# Board of Adjustment

## Staff Report

**CASE NUMBER:** BA14-058 (PLN2014-00534)  
**STAFF PLANNER:** Kaelee Wilson, Planner I  
**LOCATION/ADDRESS:** The 2800 block of North Power Road (west side)  
**OWNER:** MDC Ridgeview Plaza  
**APPLICANT:** Jeffery Maas, Gensler

### **Bank of America Riverview Plaza ATM**

Description  
OVERALL ARCHITECTURAL REFERENCE SITE PLAN  
GRADE LEVEL

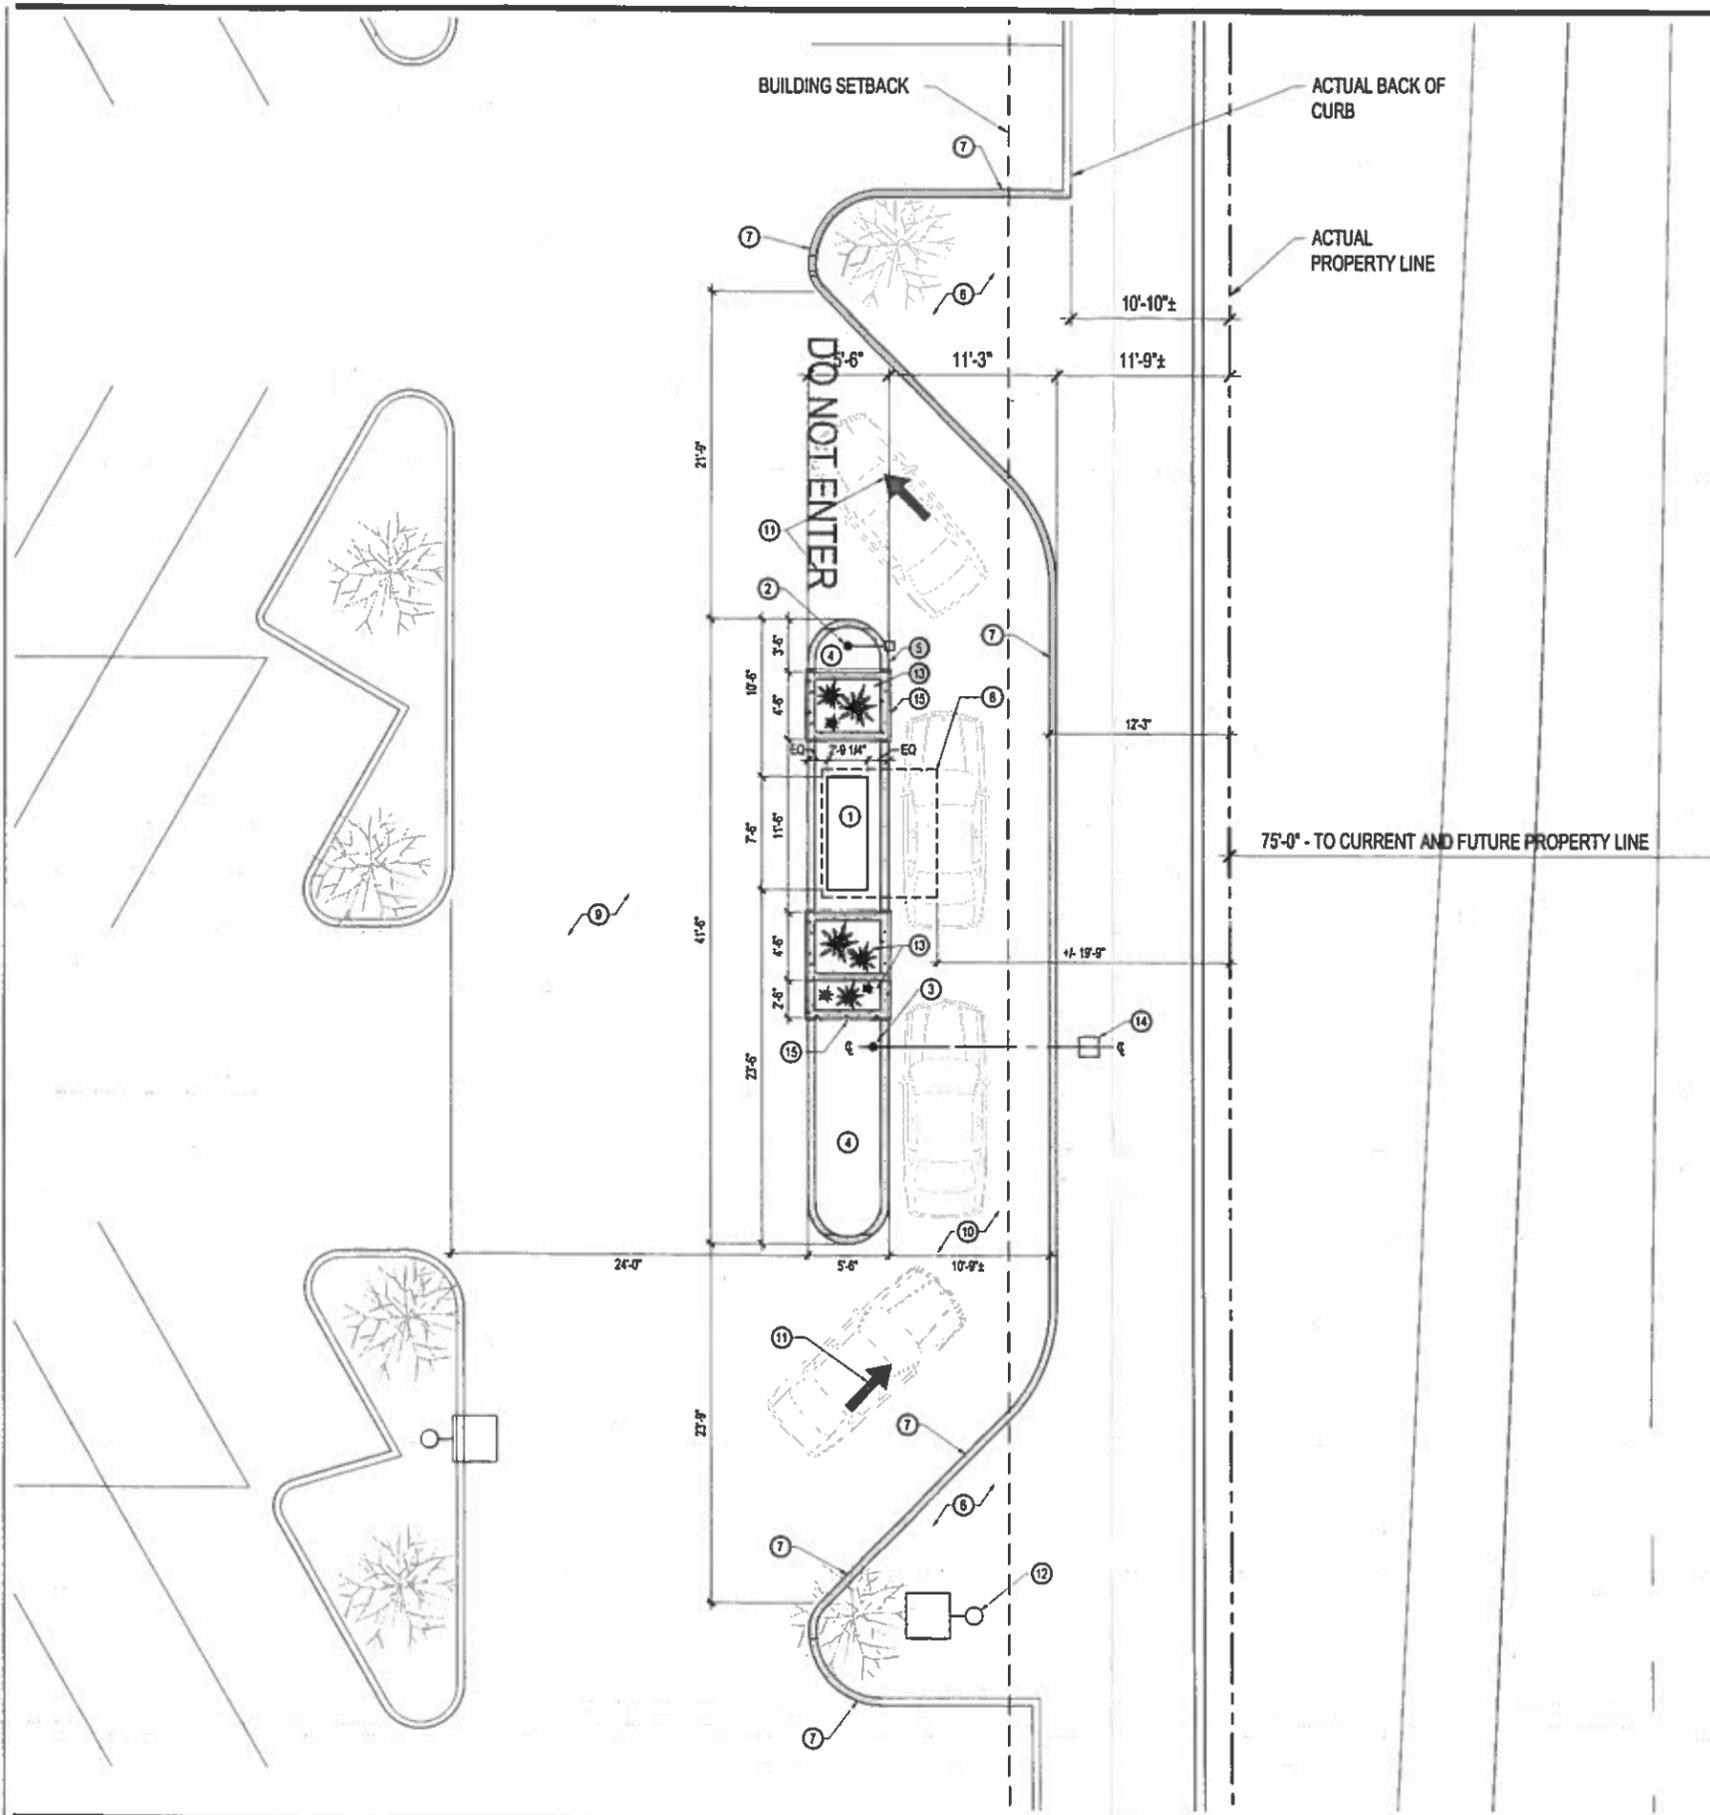
#### ***1. Kiosk encroaches 5' into the required 20' landscape setback.***

#### ***2. Please dimension future width line on site plan.***

**9. Foundation base is required around the kiosk. Five feet is required on three sides and two feet (flush curbing) on the drive thru side.**

There has been confirmation that the minimum front landscape setback that is required on the Power Road frontage is 15 feet. The drive-thru lane has been shifted further west (away from Power Road) to align with the existing curb to be in conformance to the existing conditions previously allowed on-site. Subsequent to the initial submittal of this letter, actual field survey data showed that the existing curb alignment is approximately 10'-10" back from the existing property line.

The property line at the proposed Kiosk location is 75' from the center line of Power Road. The balance of the property line along Power Road is currently at 65' from the centerline of Power Road. It was confirmed with the City of Mesa that the furthest planned ROW expansion along Power Road is 75' from the centerline of Power Road. In effect, the current property line nearest the proposed ATM kiosk is at the furthest planned ROW expansion and no further adjustments are anticipated.

Architectural site plan proposes to provide a foundation base that is 10'-6" feet deep to the north, 1'-4 3/8" feet to the east (drive thru side) for functionality, 23'-6" feet deep to the south, and 1'-4 3/8" feet deep to the west. Therefore the foundation plan north dimension of 10'-6" feet and south dimension of 23'-6" feet substantially exceed the minimum 5 feet requirement. The west side dimension (or third side) is 1'-4 3/8" feet and less than desired and the subject of the formal SCIP request. The total foundation base area provided for the ATM is 169 sq. ft. and only 115 sf is required with 5 feet on three sides. The design proposal suggests the required foundation area is simply being reallocated around the ATM.

(Should the 5 feet to the west side of the ATM be required it would automatically dictate that the existing parking 24 feet drive be shifted further west, put a serpentine curve within the impacted drive, encroach into two existing landscaped islands with 4 mature trees to be relocated, and remove 6 additional parking spaces. We hope that the City of Mesa agrees that such negative impacts do not serve the retail center well and do not warrant the minimal benefit of 4 additional feet being added west of the ATM.)

**EAST ELEVATION (FROM POWER ROAD)**  
SCALE: 3/8" = 1'-0"

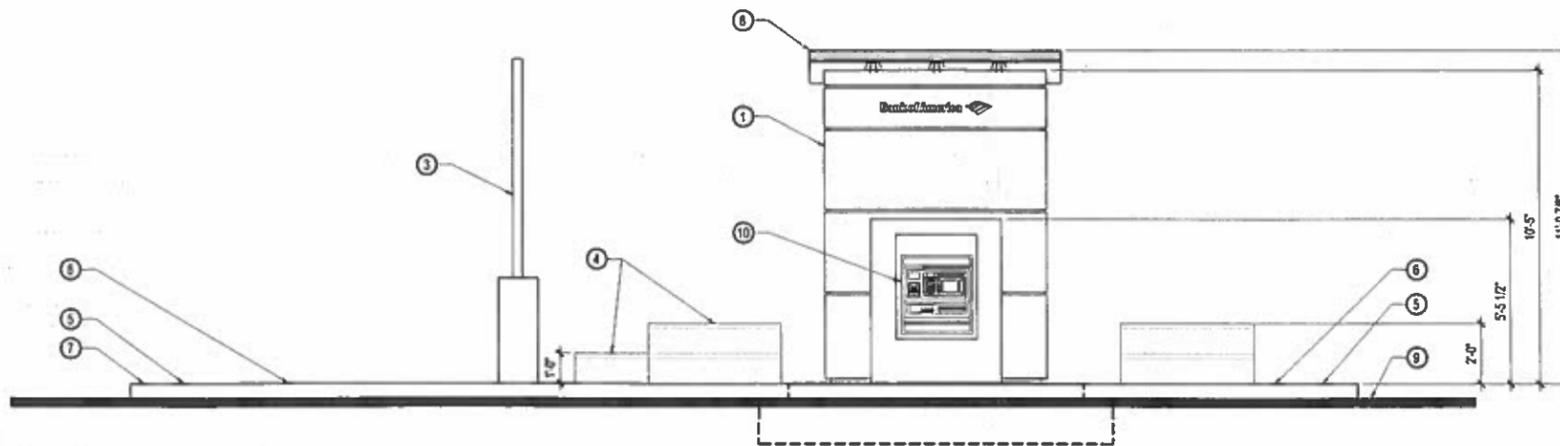
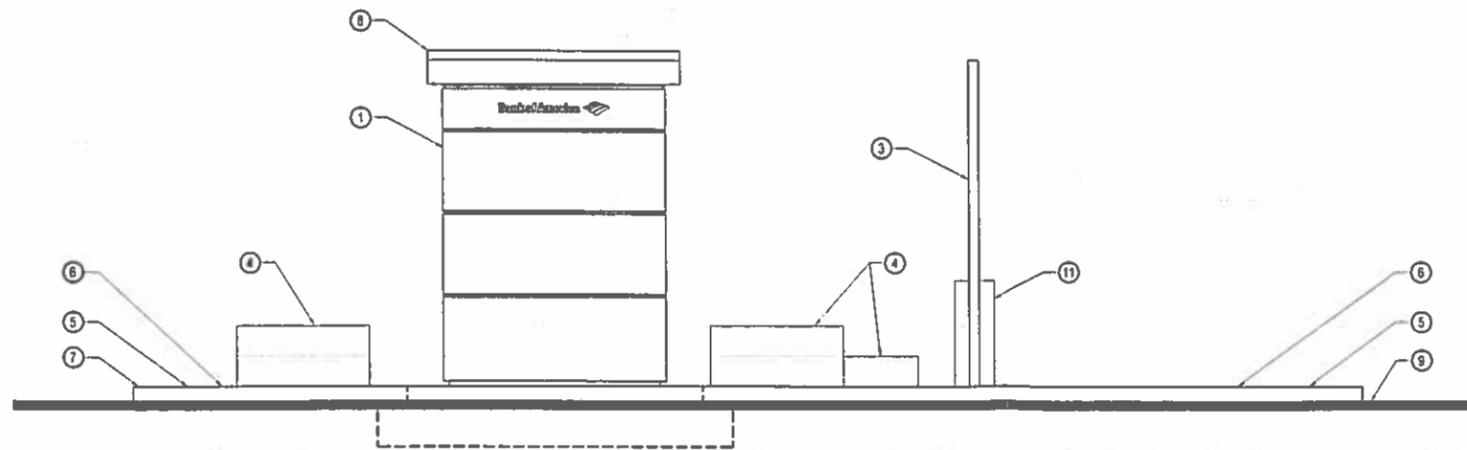
**3. The signage on all four sides of the kiosk is not allowed; please submit revised elevations with reduced signage.**

**4. The signage also exceeds 50 percent of the width of the kiosk which is a violation of code.**

**5. Please replace the bollards with decorative planters.**

The kiosk signs have been revised with the signs being completely removed on the north and south elevations. Signs on the west and east elevations have been reduced in size and length as required, and meet the City of Mesa requirements.

Kiosk signs on the west and east elevations have been reduced in vertical height and therefore in length to be in compliance with this requirement.

Many different design options have been explored and have respected the need for vertical devices at the bollard locations that protect the ATM unit from vehicular impact and as required by the Bank of America. Design proposes to provide integral, low profile cast in place concrete planters on either side of the ATM in lieu of bollards. The planter is proposed to be board-formed with a textured or patterned surface that will visually anchor the composition. Natural desert plantings selected from the Desert Uplands approved plant list will be integrated into the planters. The 24" high protective planters will have an integrally designed bumper that will reinforce the horizontal banding design element of the project while providing a level of protection from damage to vehicles that may inadvertently drive against the sides of the planter.

**COLORED WEST ELEVATION**  
SCALE: 1/4" = 1' - 0"

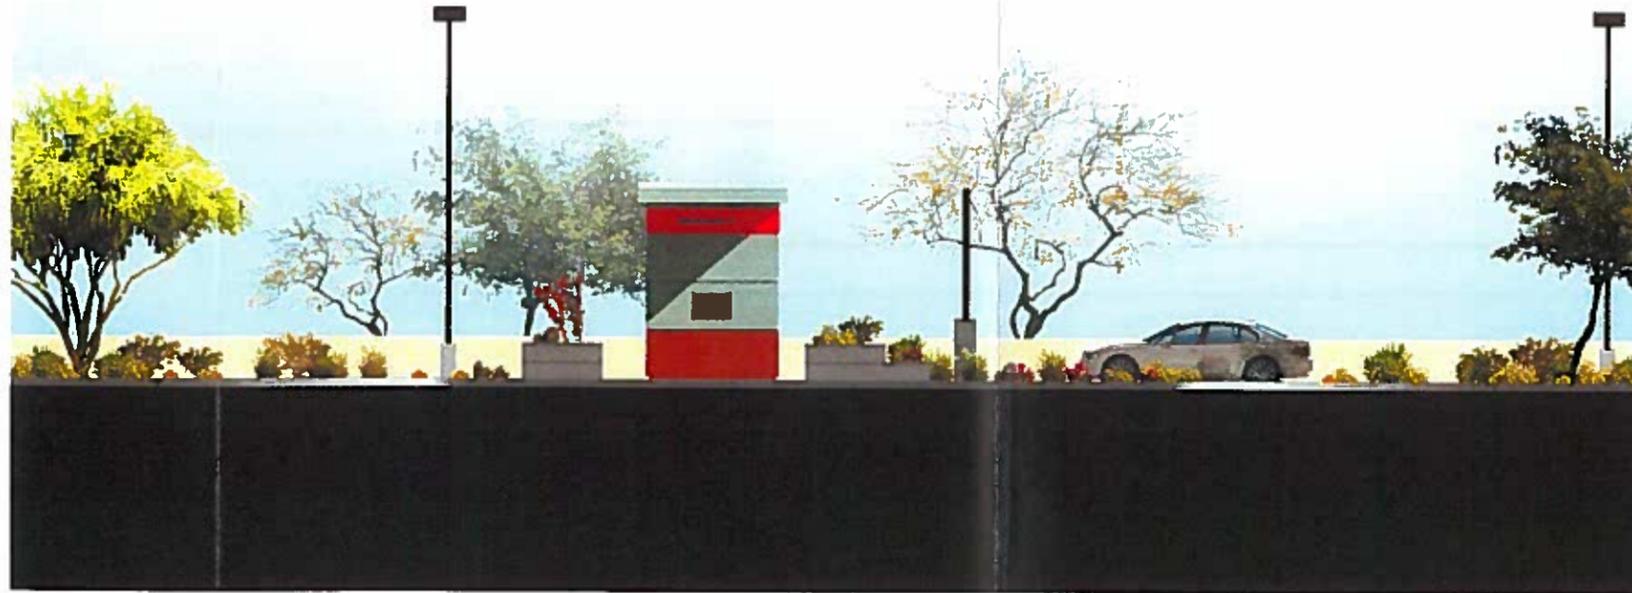
**6. Please choose material for the kiosk that better matches the shopping center.**

**7. The canopy needs to be better designed to integrate with the surrounding center.**

The ATM has been reclad in a textured plaster with a light colored P-3 paint to match the existing center.

The canopy has removed the earlier red color and is being painted a P-5 paint or BOA Champagne Metallic MP21314 Semi-Gloss, which is visually compatible with the existing center.

The one drive being provided is visually screened with a 41'-6" long and landscaped island that mitigates a broad-side view of the drive. Landscape will meet current City of Mesa standards and be much denser than that which exists immediately to the north, east, and south of this area. The provided west elevation shows this visual screening. An existing 3'-0" high solid plastered wall that runs north/south and east of the new drive also visually screens it from the Power Road exposure. Our east elevation reflects this wall in the foreground to mitigate views from the street.
